XII STONES INC.

ADDENDUM 2

Project: Wayne Maintenance Facility Roof Replacement
District 3
NDOR Building Number: 33702
Project: AFE I-302

13 FASCIA DETAIL @ ROOFS "A" & "B"
EC-2 NO SCALE

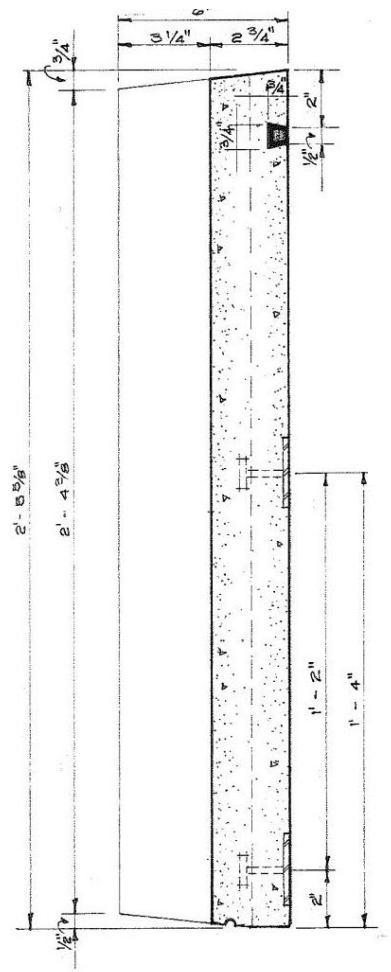
1. Sheet EC-2
 - A. Add Detail Numbers 13/EC-2, 14/EC-2, 15/EC-2 and 16/EC-2 from the attached drawing to Sheet EC-2 of the construction drawings.
2. Sheet D-3, Note # 12
 - A. Delete the second sentence in its entirety and add the following new sentences after the first sentence, “The contractor shall manage the removal and disposal of asbestos containing materials either by the contractor’s own forces or by an appropriate removal company. The contractor is responsible for managing the schedule and scope of work for the entirety of the project and shall indemnify the Department of Roads from any delay of work issues”.
